PSPB COA PROPOSAL - CORRECTIONS

GRAND CENTRAL BLOCK

200 S 1ST ST, Seattle, WA 98104

PERMIT NUMBERS:	6714121-CN 3035920-LU 410949 (SIP)
OUTLINE OF PROPOSED WORK:	<ul style="list-style-type: none">Substantial alteration/addition of the Buttnick, City Loan, and Grand Central buildings that maintains the existing ground floor retail and restaurant uses with office uses aboveConnect all three buildings to operate as a single building while maintaining their individual historic characterAdd single-story penthouses above the Buttnick and Grand Central buildingsMeet or exceed LEED Gold + requirementsSelectively remove interior elements to accommodate future TI workSelective removal of exterior elements (see elevations)Install new mechanical, electrical, plumbing, and fire protection systemsBuilding upgrades as necessary to comply with substantial alteration requirements, including: seismic upgrades, fire and life safety upgrades, efficient mechanical electrical and plumbing systems, and other energy performance improvements

ROOFTOP COVERAGE

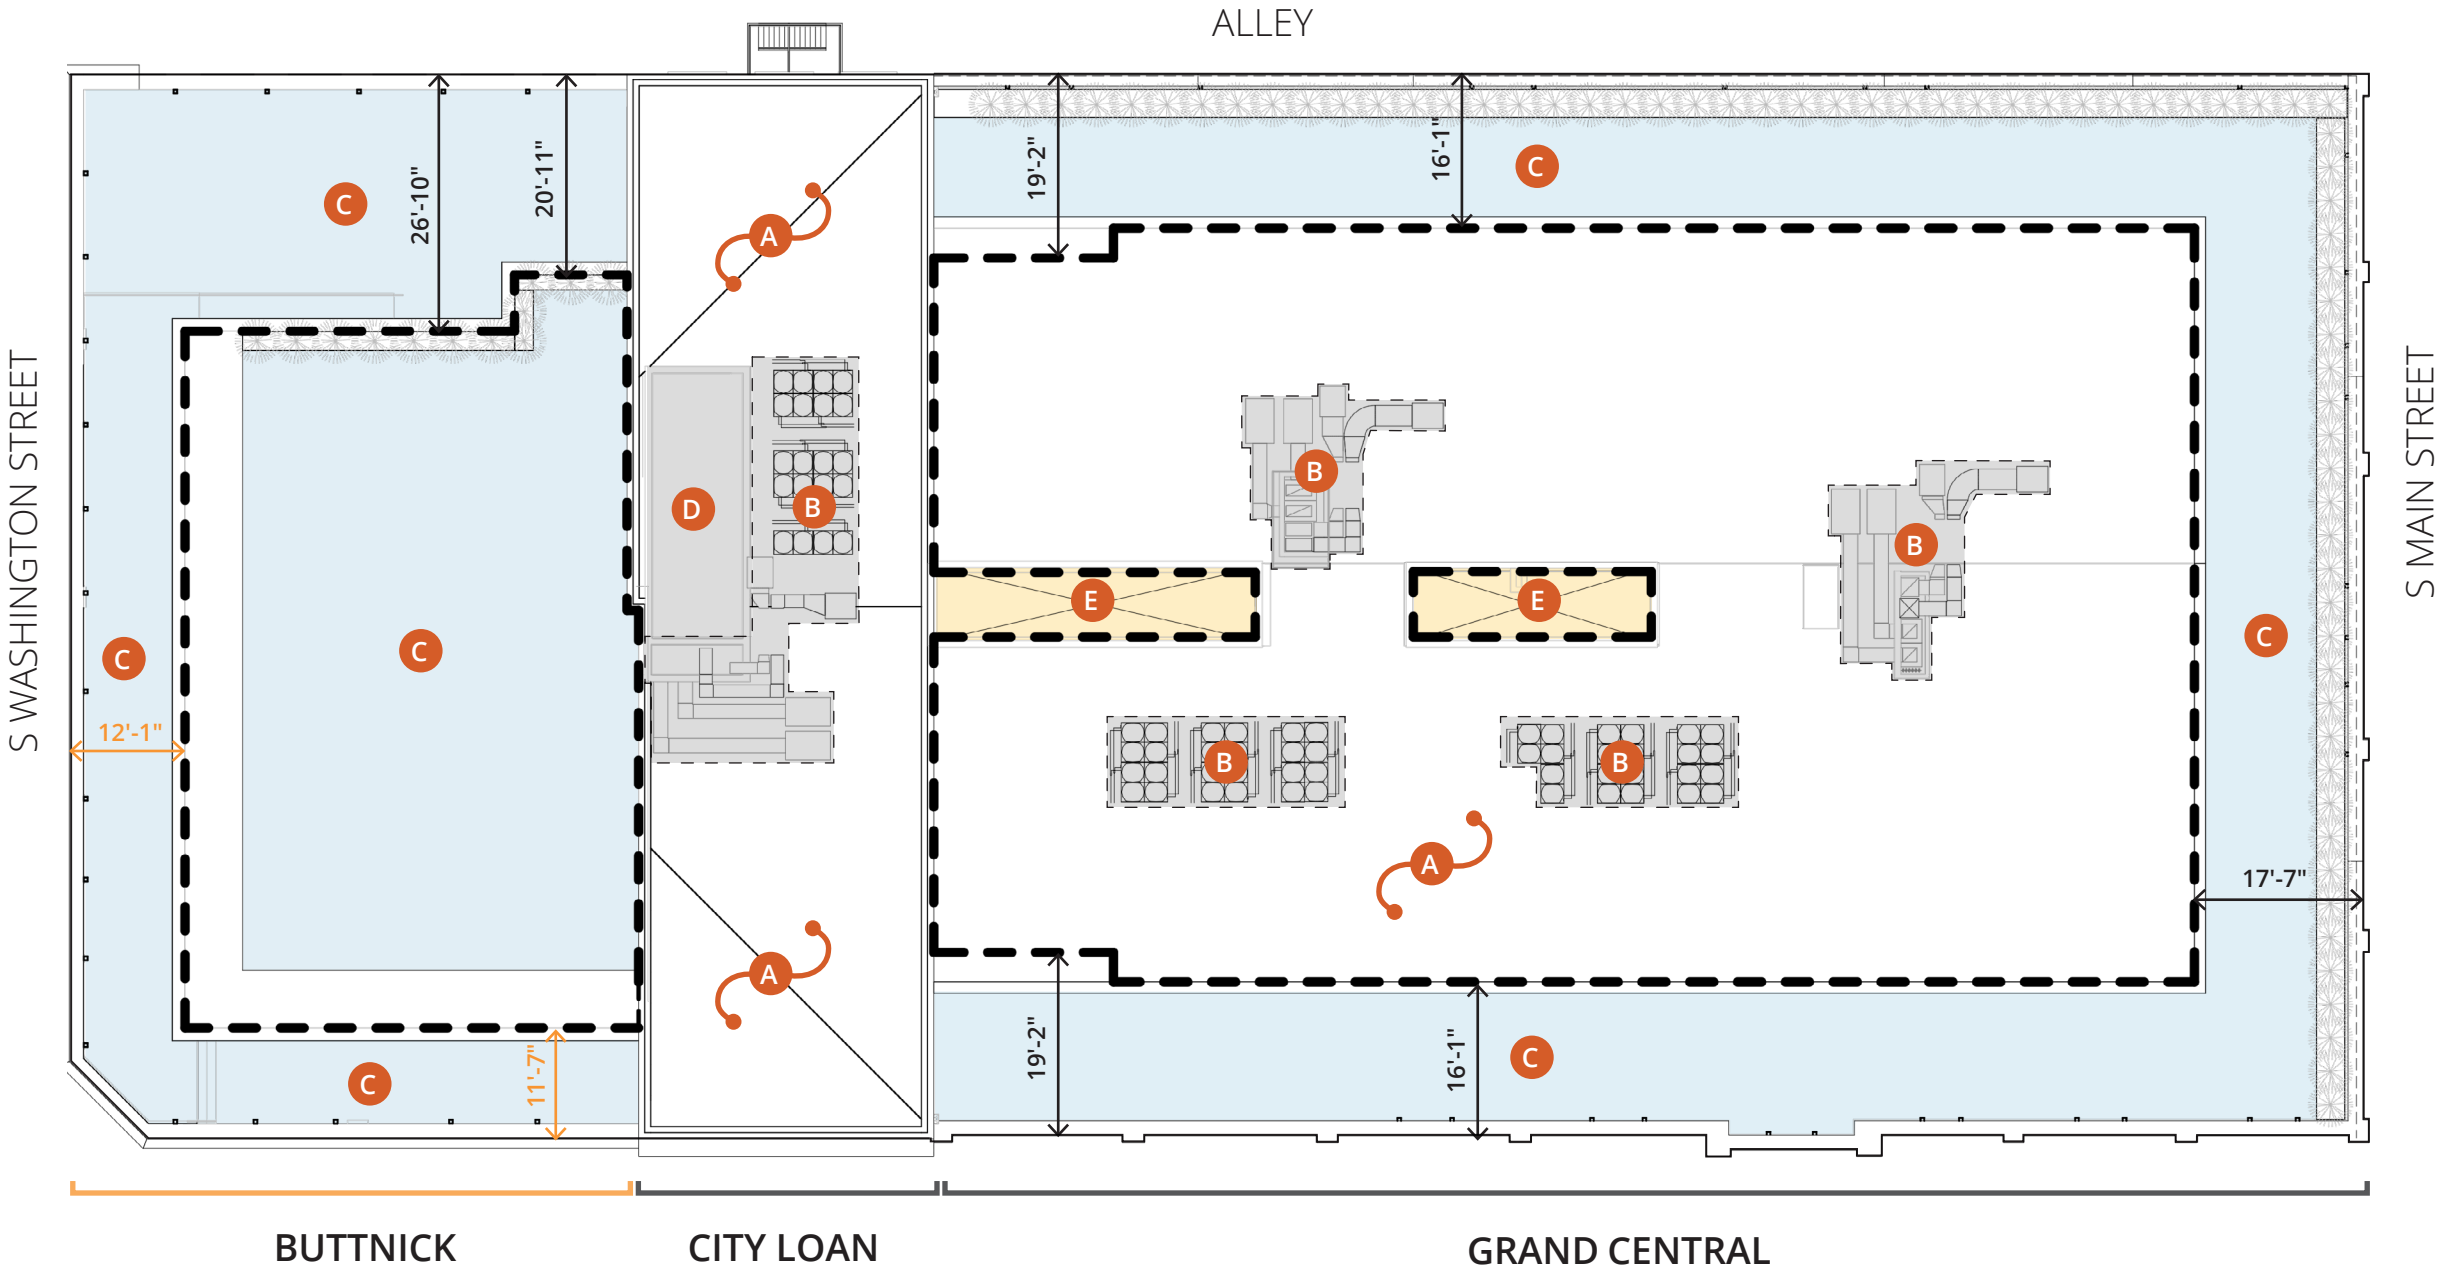
The plans stated that the coverage is 53% which is over the 50% allowed in the code for use as an office or residential penthouse. SMC 23.41.012 lists measurements and maximum size of use as items that are not departable. (Staff Report 8/5/2020)

The penthouse has been reduced to 50% roof coverage.

Total building area:	26,646 SF	
Total Office penthouse area:	13,321 SF	(50%)
Total Elevator penthouse area:	321 SF	(1%)
Total Mech penthouse area:	1,482 SF	(6%)

BUTTNICK PENTHOUSE - VIEW STUDY

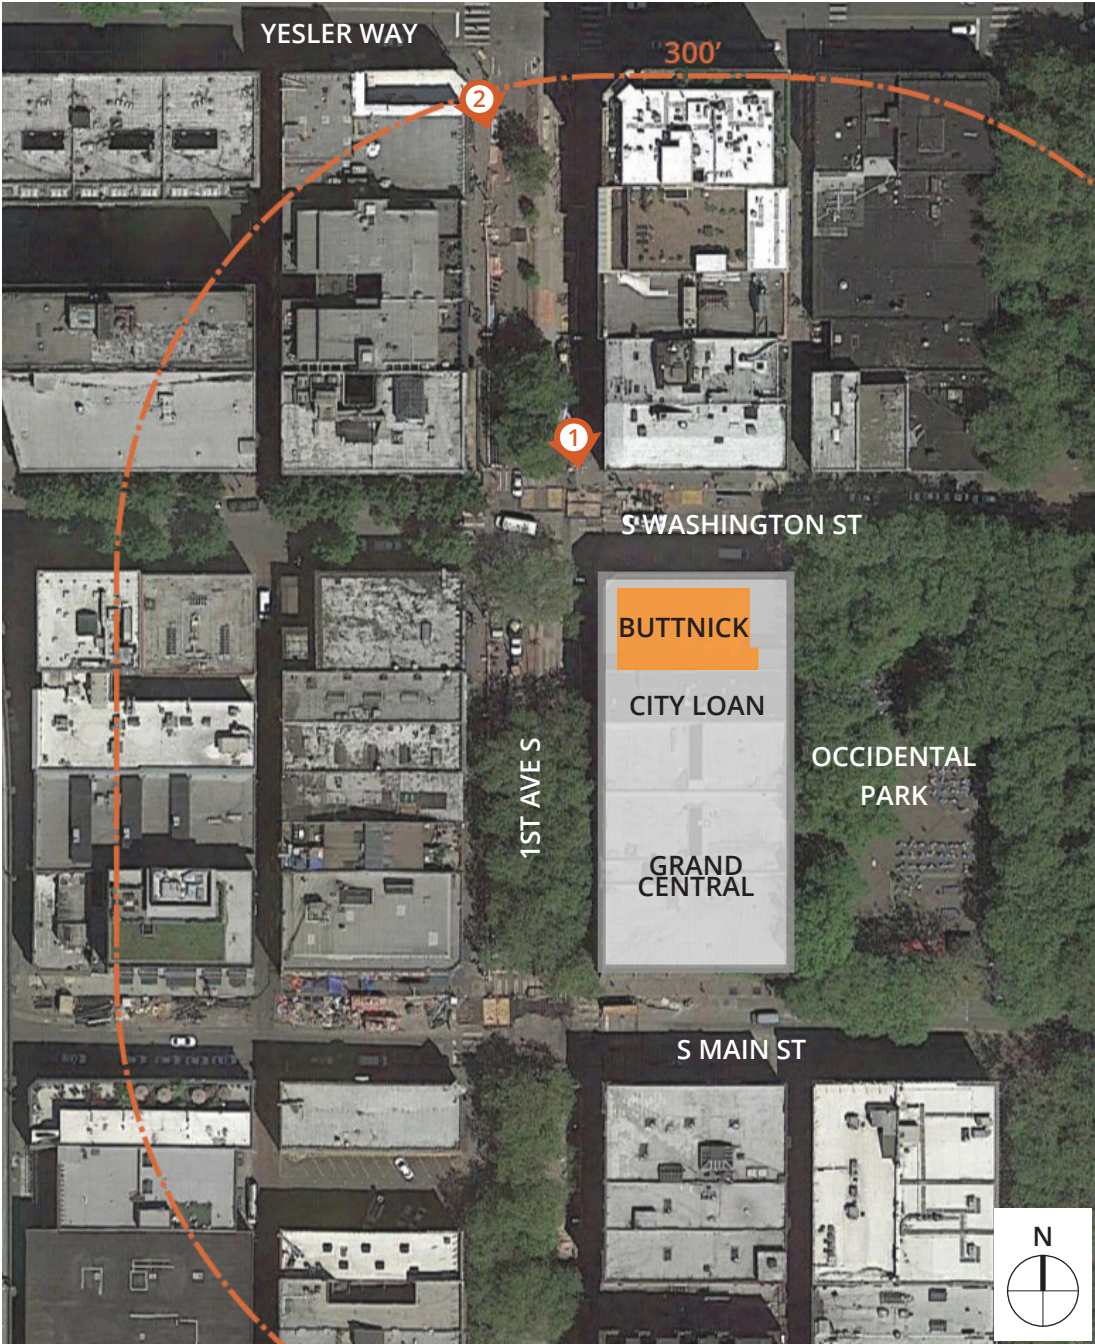
The Board would first have to determine if the penthouse is minimally visible from 300 feet. It appears visible in what is provided. (Staff Report 8/5/2020)

Photos are from the penthouse mockup performed in March 2021. The penthouse height and footprint shown are a reduction compared to the previous Board Briefing.

BUTTNICK PENTHOUSE - VIEW STUDY

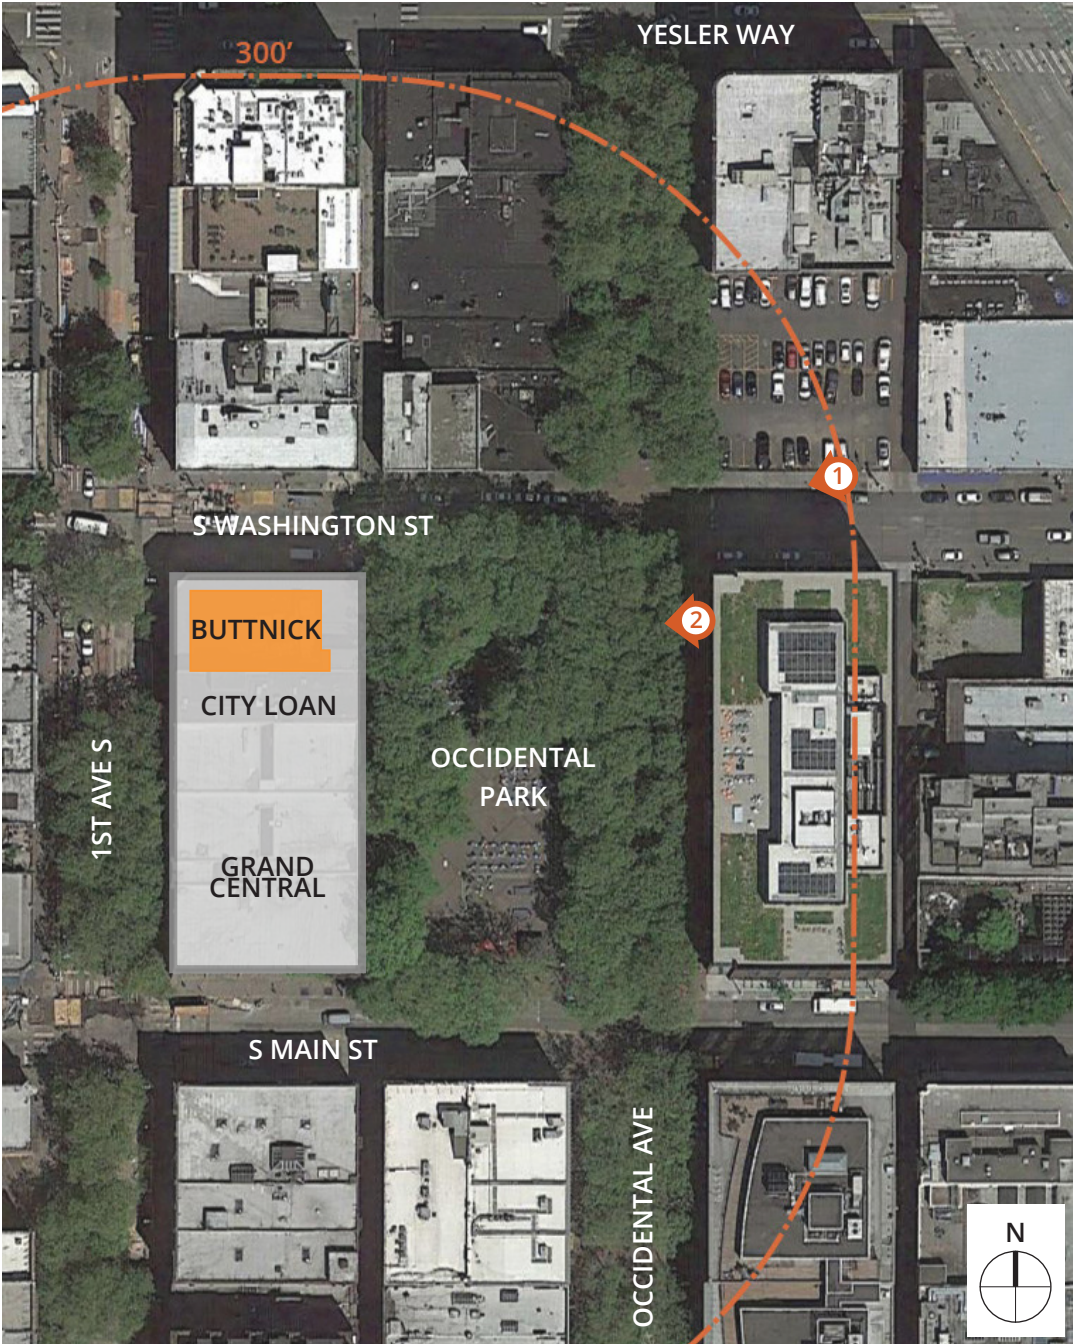
The Board would first have to determine if the penthouse is minimally visible from 300 feet. It appears visible in what is provided. (Staff Report 8/5/2020)

Photos are from the penthouse mockup performed in March 2021. The penthouse height and footprint shown are a reduction compared to the previous Board Briefing.

BUTTNICK PENTHOUSE - VIEW STUDY

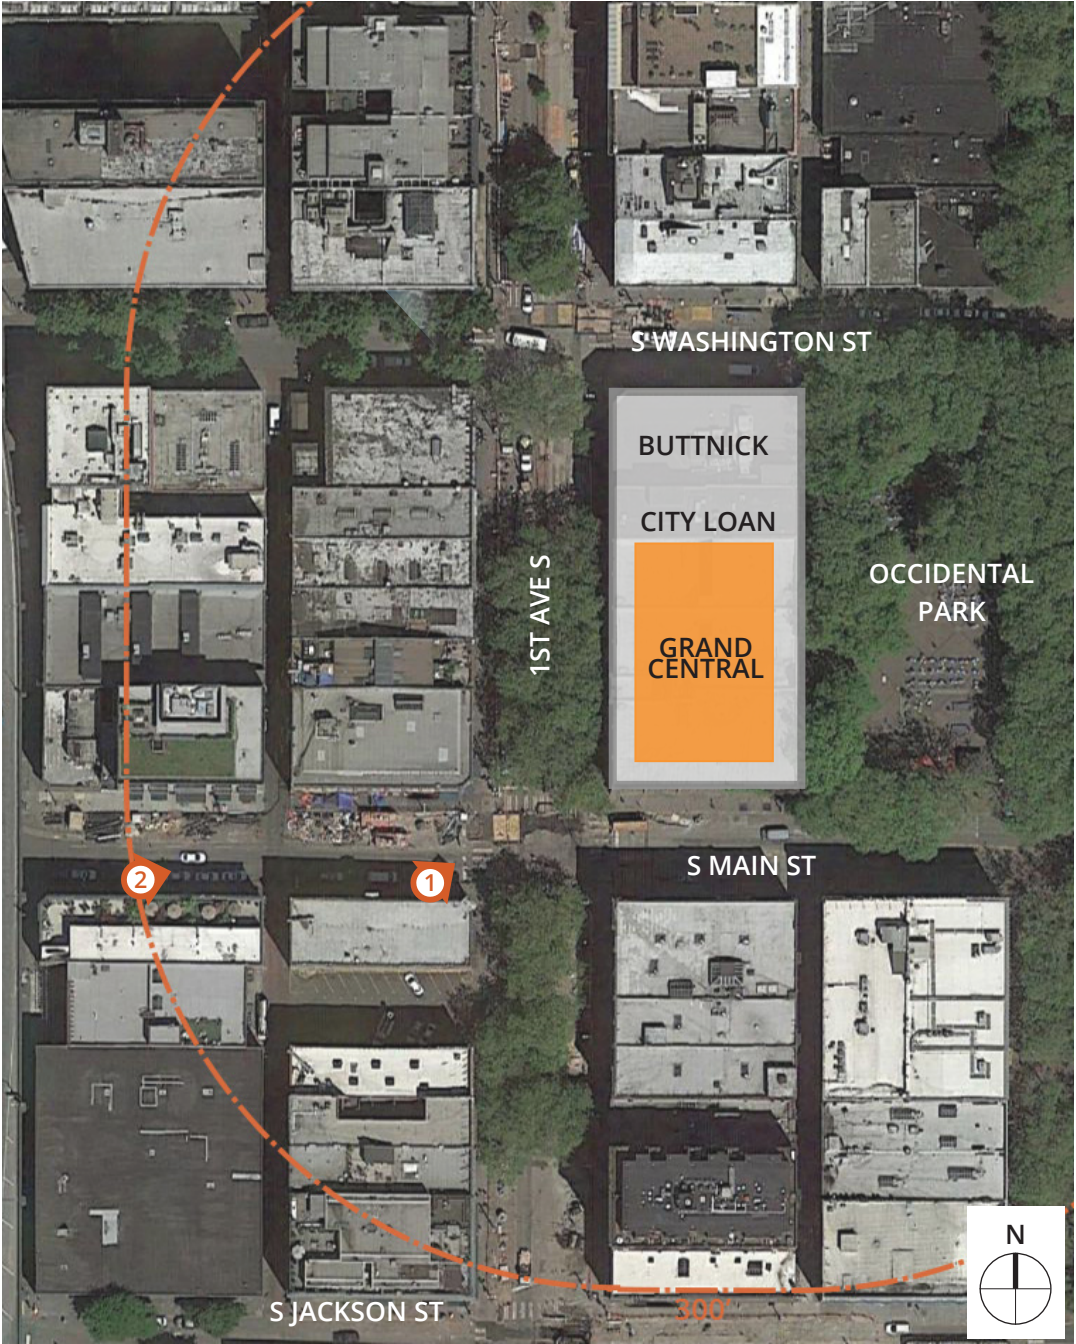
The Board would first have to determine if the penthouse is minimally visible from 300 feet. It appears visible in what is provided. (Staff Report 8/5/2020)

Photos are from the penthouse mockup performed in March 2021. The penthouse height and footprint shown are a reduction compared to the previous Board Briefing.
